CITY OF  
**ISSAQUAH**  
DEVELOPMENT SERVICES

**TALUS PRELIMINARY PLAT  
PARCELS 7, 8, 9  
STAFF REPORT**

**March 25, 2014**

**Project:** TALUS Preliminary Plat, Parcels 7, 8, 9 (PP14-00001)

Parcel 7's terraced walls

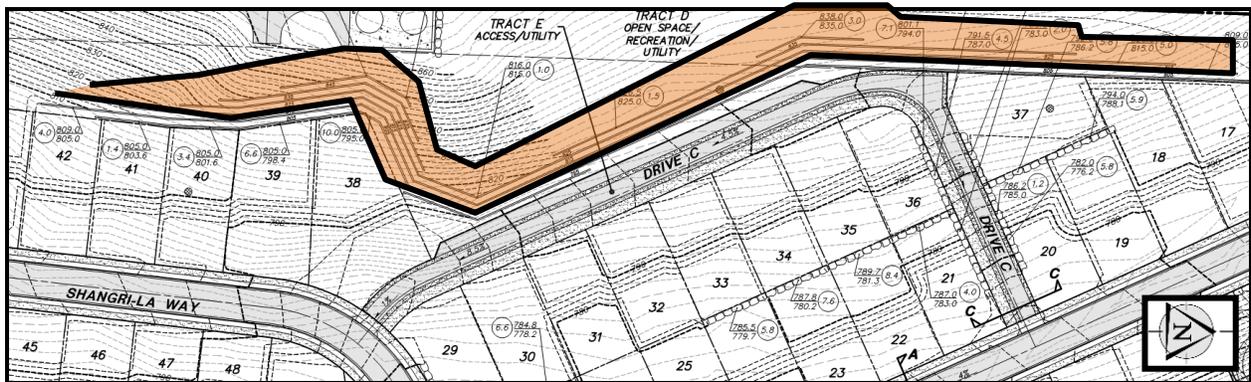
In some cases these walls are tall but not located where people will be near them, i.e. they separate lots above the wall from natural open spaces areas below them. However in other cases the walls, especially the very tall ones, will be in close proximity to pedestrians, e.g. the trail along the bottom of the Parcel 7 east wall. The guidelines for walls say “When practical, terrace retaining walls to reduce bulk and to create planting areas.” Thus terraced walls shall be designed and spaced so that plantings, including trees, can be placed between them in order to provide visual relief, integrate them into the site, and reduce their visual bulk. **(Condition 7)**

Parcel 9's terraced walls

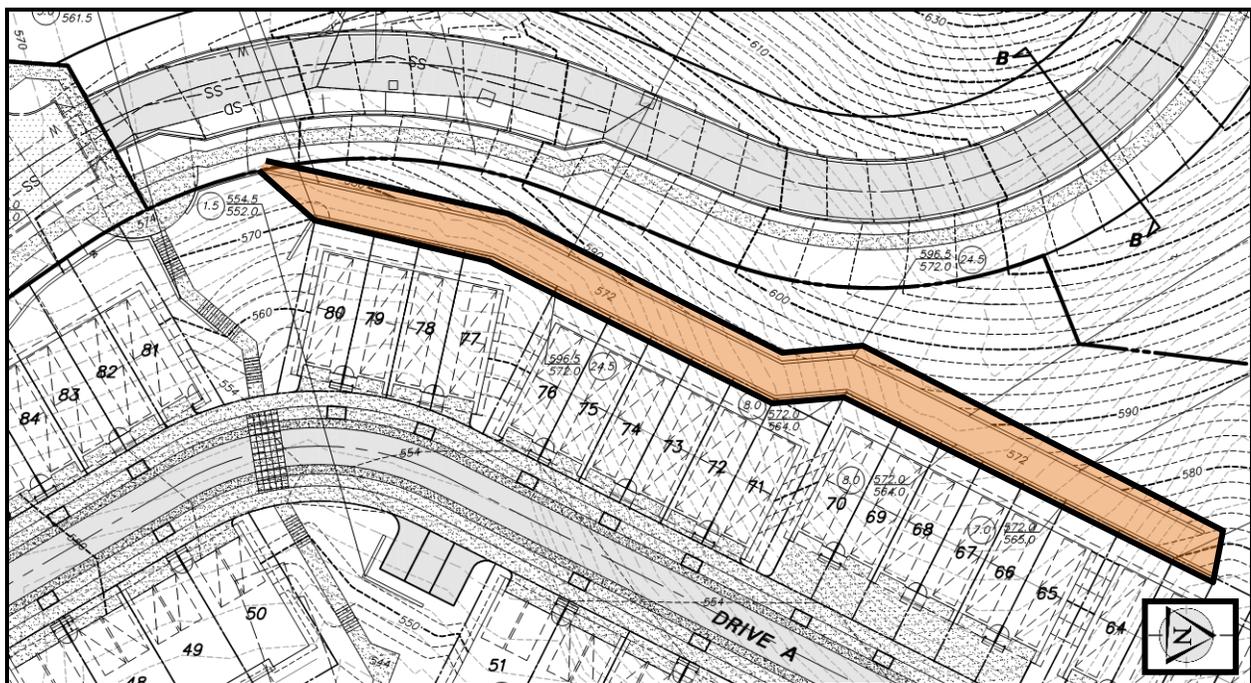
However, in some circumstances, the reason the wall is so tall is that it's chasing the slope, and terracing wouldn't reduce the wall height, you would just have a series of very tall walls. The only way to reduce the height would be to separate the parcel into more than one building pad, which would be less efficient for lot layouts, but might reduce wall heights. That does not seem practical. The guidelines also say walls need to add visual interest to the neighborhood and where large and/or tall walls are present, articulate large expanses of walls to provide visual relief and reduce visual bulk and size. In addition, where large walls are used, landscape plantings and/or artwork are employed to soften the visual effect. Thus all the walls need to be designed in ways that make them visual interesting, the larger ones are articulated, landscape material is added to provide scale when a pedestrian is nearby. A trail is proposed at the base of the wall in Parcel 7. Landscaping should be provided between the wall and the trail in order to create pleasant environment and to reduce the presence of the wall for trail users.

**(Condition 8).**

Parcel 7's fill wall  
Open Space and Parks

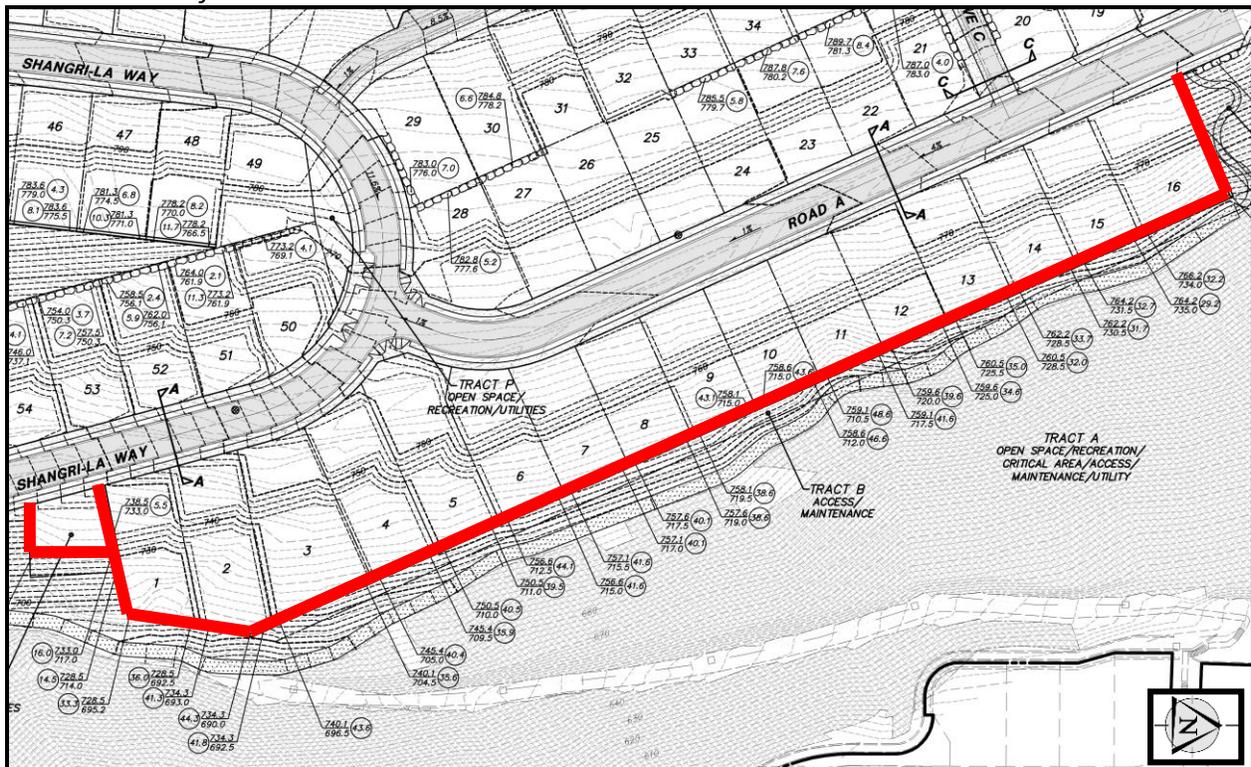
Finally, the guidelines discuss walls as being constructed of keystone, stone, rockeries, and appropriate materials. Many types of walls appear to be indicated in the plans, some walls aren't specified, and other notes indicate some existing walls are being retained, e.g. the soldier pile wall along the eastern edge of Parcel 9. Soldier pile walls are not appropriate unless they are faced with an alternative surface and all walls need to be well integrated into the site, be consistent with the character of the parcel, and make sense all together (not a hodge-podge). *This will be verified with Construction Permit No. 23.*

Road A and Drive C: Parcel 7 – Residential Streets

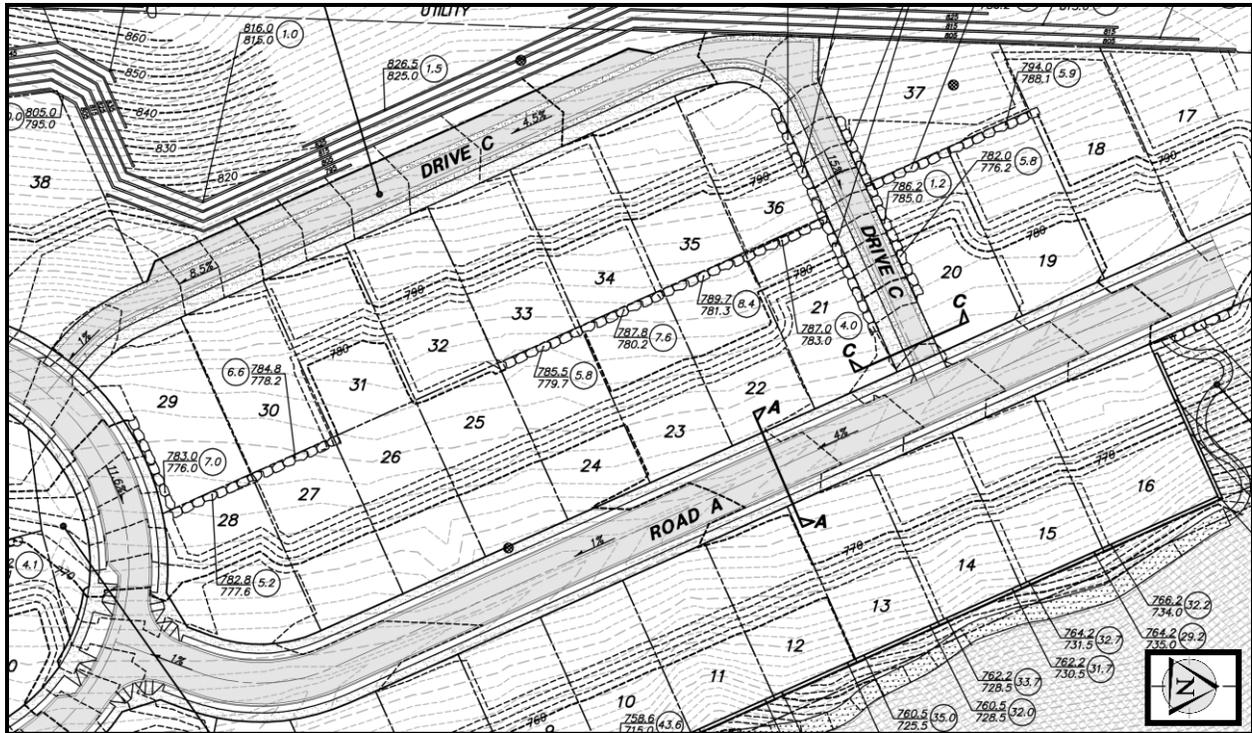
**Road A:** Road A, serving Parcel 7 is designed as a standard Residential Street. Road A will provide access to the Parcel 7's northern lots. The Right-of-Way will extend to the northern boundary of the plat in order to provide a future connection to the parcels located within King County to the north.

Drive A: Parcel 9 – Residential Street

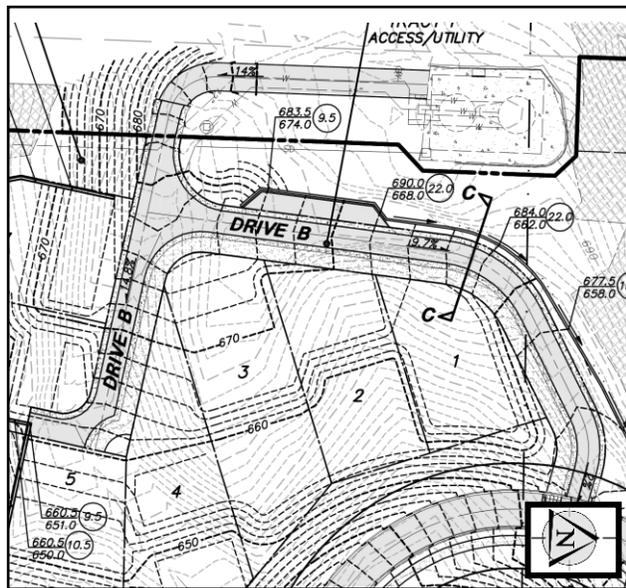
**Drive B:** Drive B, serving Parcel 8 is designed as a Residential Street per Appendix F. The sidewalk has been removed on the west side of the street where residences are not present per AMM14-00002. The road rises in elevation approximately 30 feet (up to 15% grade) from the intersection with Shangri-La Way to its highest service point at the hammerhead turnaround for Eastside Fire and Rescue access adjacent to Lot 7. A short section of road will continue to the north and west and will provide access to the existing 752 Reservoirs. Because of the steep grades in Parcel 8, the amount of on-street parking that can be accommodated is limited to the section of street to the west of Lots 2 and 3.

The approval of AMM14-00002 requires that between 31 and 38 feet of width be provided within Tract F in order to accommodate the road, sidewalk, planters and parking. The application specifies only 26 feet of width for these elements. Compliance with AMM14-00002 will require additional width for the planters and sidewalk. This will be verified with the site work permits and the Final Plat. **(Condition 17)**

- 17 Per AMM14-00002, the Parcel 8 road and Tract F (Drive B) must be widened as necessary in order to provide sidewalk and planter facilities. This condition will be verified with the Final Plat.
